RFQ NUMBER
DNRB11007

ADDENDUM #1

EXPRESSION OF INTEREST Cacapon Resort State Park Dams Engineering Investigation and Certificate of Approval

**PERIODIC DAM INSPECTION (2009)
CACAPON STATE PARK LAKE DAM
(INDIAN RUN DAM - LOWER)
ID # 06503
MORGAN COUNTY, WEST VIRGINIA**

SITE SKETCH CACAPON PARK DAM CACAPON STATE PARK	
PROJECT NO. 09145 DRAWN BY: HNC SCALE: NTS	CHECK BY: MEP DATE: 10/22/09
CIVIL TECH ENGINEERING	
FIGURE 1

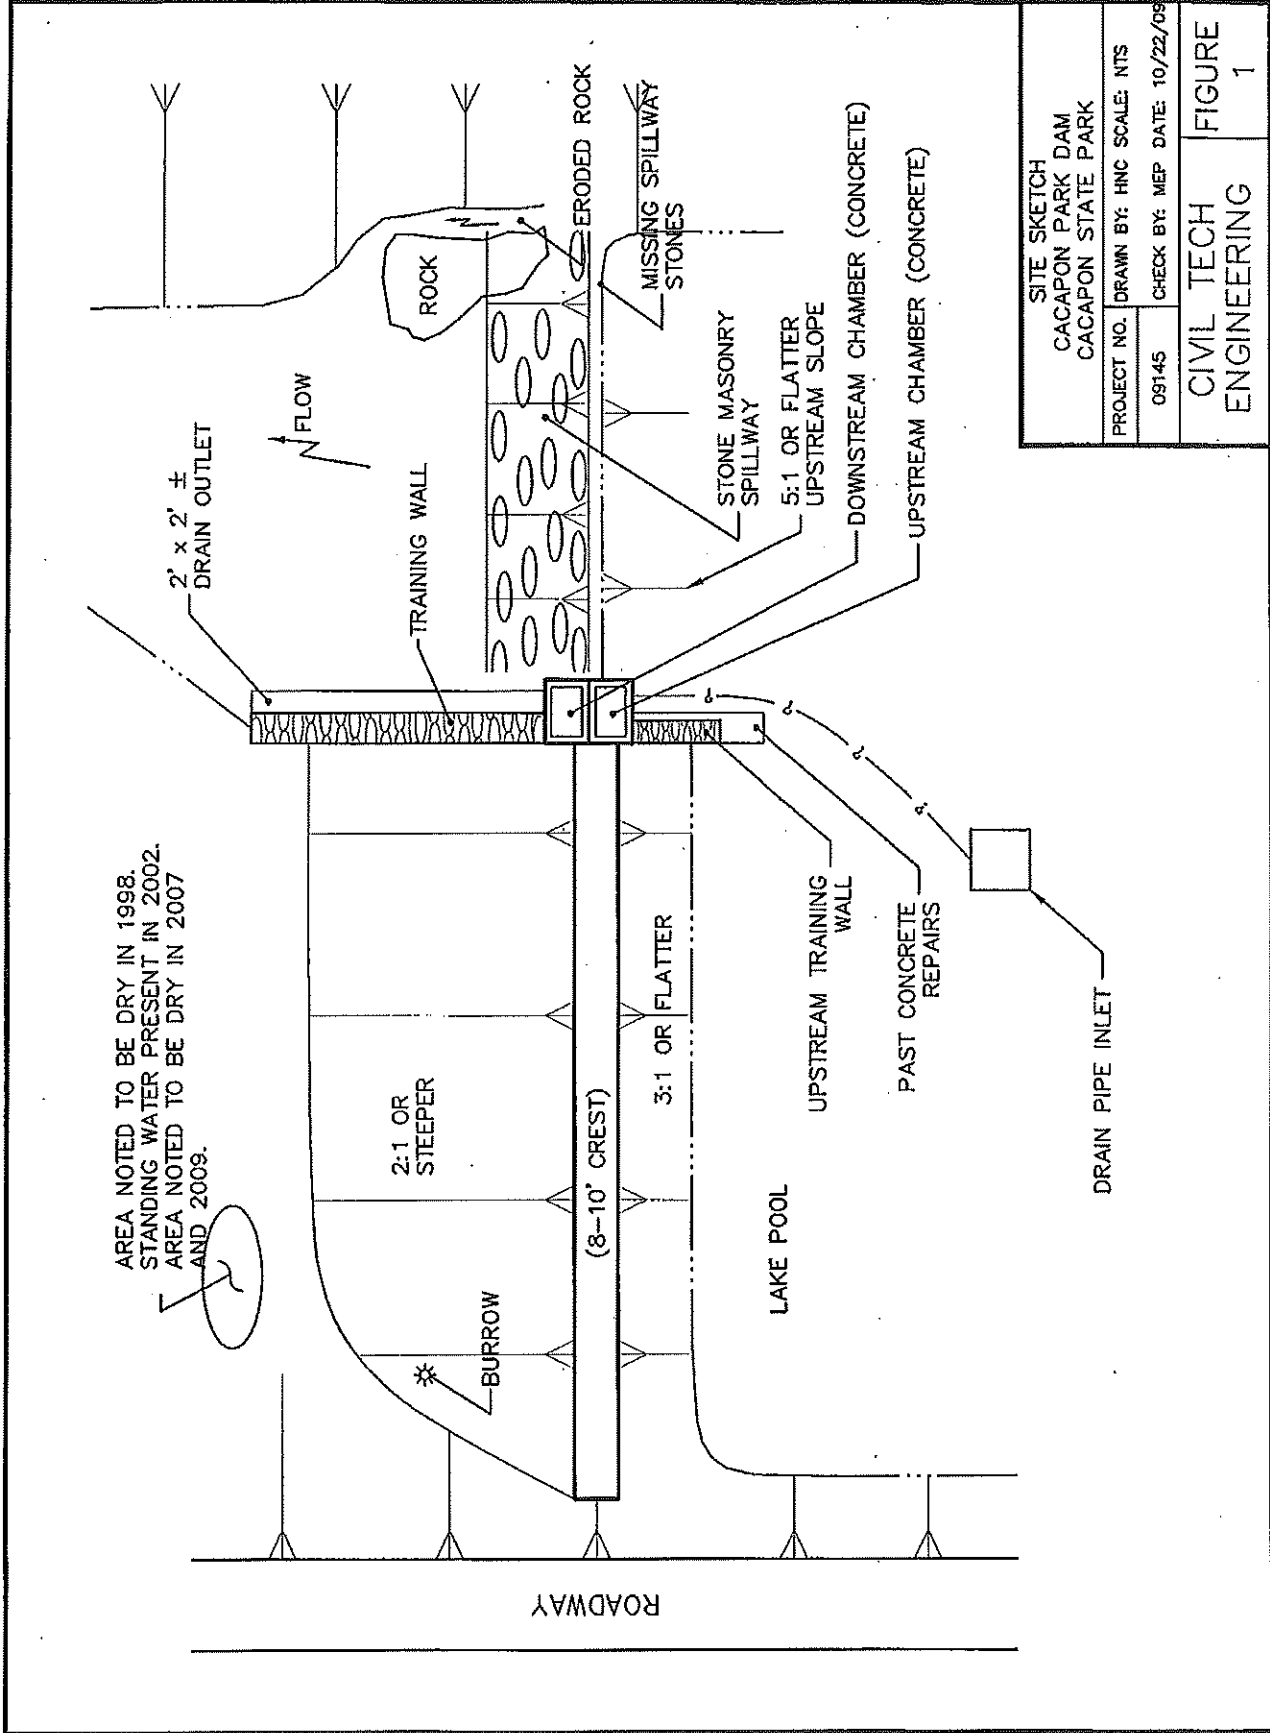
4. An animal burrow was observed on the left side of the dam near the toe and left groin area during our inspection performed in 1998. See Figure 1. This burrow was not visible during the 2002 inspection and was observed to be inactive during the recent 2007 inspection. The burrow was not present at the time of this inspection.

5. Similar to our past inspections, no seepage was noted on the slope or at the toe of the dam. Based on our review of past inspection reports, a wet area has been noted to be present downstream of the toe of the dam on the left side as shown on Figure 1. This area was dry during our recent inspection as well as the inspections performed in 2007, 2005, and 1998. However, standing water was present in this area during our 2002 inspection. The reader will note, it was raining during that inspection and this area is poorly drained. Since the area is currently dry and was dry in 2007, 2005, and 1998, it is our opinion the source of this water is surface runoff and poor drainage, not seepage from the dam.

out appear were replaced at that time. However, some of the spillway stones were observed to be missing and erosion of the sandstone bedrock is progressing in this area. See Figure 1 and Photo No.s 15 and 16. As discussed with Mr. Ambrose, the missing stones should be replaced and the bedrock erosion filled with concrete as maintenance. Failure to make these repairs timely could allow the spillway to wash out again and result in the loss of the pool.

1. The inlet to the box culvert appears to consist of two vertical chambers located along the left side of the spillway as shown on Figure 1. Based on recent information obtained, we understand the culvert is drained by an in-lake valve located somewhere upstream of the spillway guide wall. The chambers have been capped with concrete and are not accessible.
2. A view of the box culvert outlet is shown in Photo No. 11. Flow was observed exiting the outlet which is an indication the valve or culvert is leaking. The culvert is broken at the outlet and the interior condition of the same could not be determined.
3. Sycamore trees and other vegetation are growing at the outlet to the box culvert during our last inspection have been removed. These trees and vegetation should be removed periodically.

AREA NOTED TO BE DRY IN 1998.
 STANDING WATER PRESENT IN 2002.
 AREA NOTED TO BE DRY IN 2007
 AND 2009.

Photo No. 5: Seepage area on the downstream slope near the left groin.

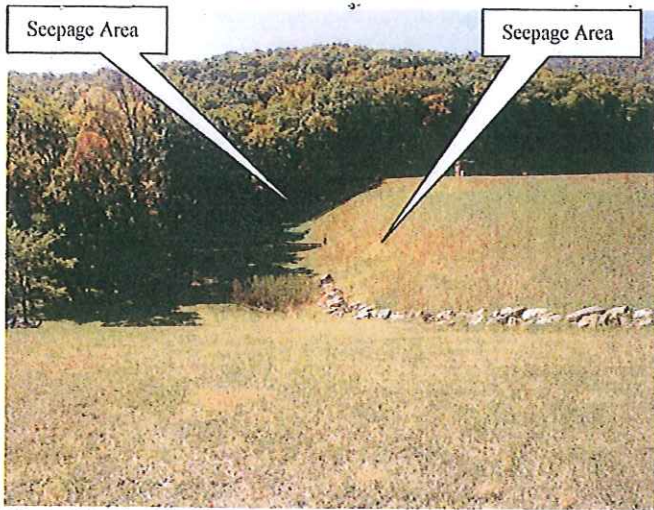
4. A new seepage area was noted on the face of the dam on the left side during the 2002 inspection which was not noted in 1998. This seepage area was also present during the current inspection. Views of this area are shown on Photo Nos. 1 and 5. Clear standing water was observed in the left seep area at the time of this inspection. However, no flow was observed. The reader will note this area was dry at the time of the last inspection. At the time of the 2007 inspection, the lake pool was approximately 3 ft. lower than the pool observed during this inspection. This increased pool may be responsible for the seepage observed during this inspection and suggests the source of the dam leakage may be positioned between a level which is 5 to 8 ft. below the normal pool. A maintenance person for the park who stopped by during the inspection stated the seep dries up during the summer. We believe the seepage dries up when the pool level drops down to 8 ft. or

more below normal pool. To confirm this, Park personnel should record the lake level along with seepage observations monthly during routine inspections. Considering the relatively high location of the seepage on the embankment slope, we recommend the seepage be monitored closely for increased flow, muddy flow, etc. especially during higher pool levels. If a high pool level should occur, the owner should observe the seepage rate and condition of the flow on a daily basis while the reservoir is returning to normal and for a period of time after the lake level returns to normal. The seeps should also be monitored closely during storm events which produce an elevated pool. Notes should be made following each inspection along with observations concerning weather and pool level. Should the seepage increase in magnitude or become muddy, this may be an indication of a serious problem. Should this occur, the owner should respond in accordance with the Monitoring and Emergency Action Plan and should contact appropriate authorities including the WVDEP Dam Safety Section immediately.

Photo No. 13: Principal spillway riser.

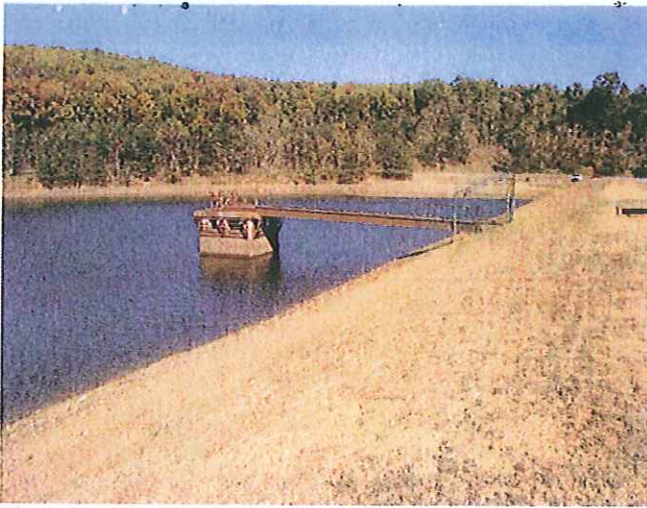
2. A walk bridge is provided for access to the riser which spans between the dam crest to the top of the riser structure. Access to the riser bridge was not restricted during our 1998 inspection. However, prior to our 2002 inspection, a fence and gate were added to the bridge to restrict access. See Photo No. 13. There is no safety rail around the top of the riser structure which could be hazardous. The gate was locked at the time of our inspection. Therefore, we were not able to access the top of the riser for inspection.

Photo No. 16: 42" CMP drain pipe outlet. Note small flow.

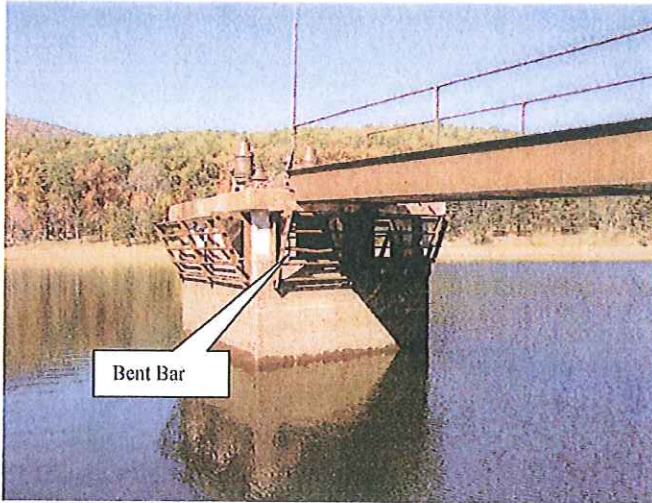
6. The outlet of the 42 inch CMP was not restricted to access during our 1998 inspection. The bar screen shown on Photo No. 16 was provided prior to our 2002 inspection and has been screwed to the concrete structure to prevent unauthorized access. However, this bar screen also prevented our entry to examine the interior of the pipe on the date of this inspection. Similar to our past inspections, flow was exiting the pipe on this date even though there was no flow entering the pipe at the riser (the lake level was below the normal pool inlet level). The flow at the pipe outlet was visually estimated to be about ½

to 1 inch deep and was similar to that observed in 2002, 2005, and 2007. This flow indicates there is a leak in the riser and/or the pipe. To investigate this potential problem further, our engineer and one of Dam Safety's engineers entered the pipe to examine the interior of the same in 1998. We advanced into the pipe a distance of about 80 feet upstream of the outlet. The reader should refer to that report for details concerning that inspection. However, in general, the pipe had deflected at the joints as much as 3 to 12 inches, standing water was present upstream of each joint, and significant leaks were observed. **As discussed in the 1998 report, the condition of this pipe is a serious concern and, as discussed herein, warrants a more detailed inspection and evaluation.**

3. The leakage occurring within the 42 inch diameter principal spillway pipe is a serious concern which could lead to significant damage to the dam and possible dam failure. We suggest plans be implemented as soon as possible to investigate and repair the pipe. In the interim, the pipe should be monitored closely for excessive flow when the pool level is below normal. The flow should be examined to determine if it is muddy which could indicate piping of soil fines from the dam embankment is occurring. Also, the dam embankment should be monitored for any holes or depressions especially along the alignment of the pipe, and the lake should be monitored for swirls or vortexes forming in the vicinity of the pipe alignment. If any of these conditions are noted, appropriate action should be taken in accordance with the Monitoring and Emergency Action Plan and appropriate authorities including the WVDEP Dam Safety Section should be contacted immediately.
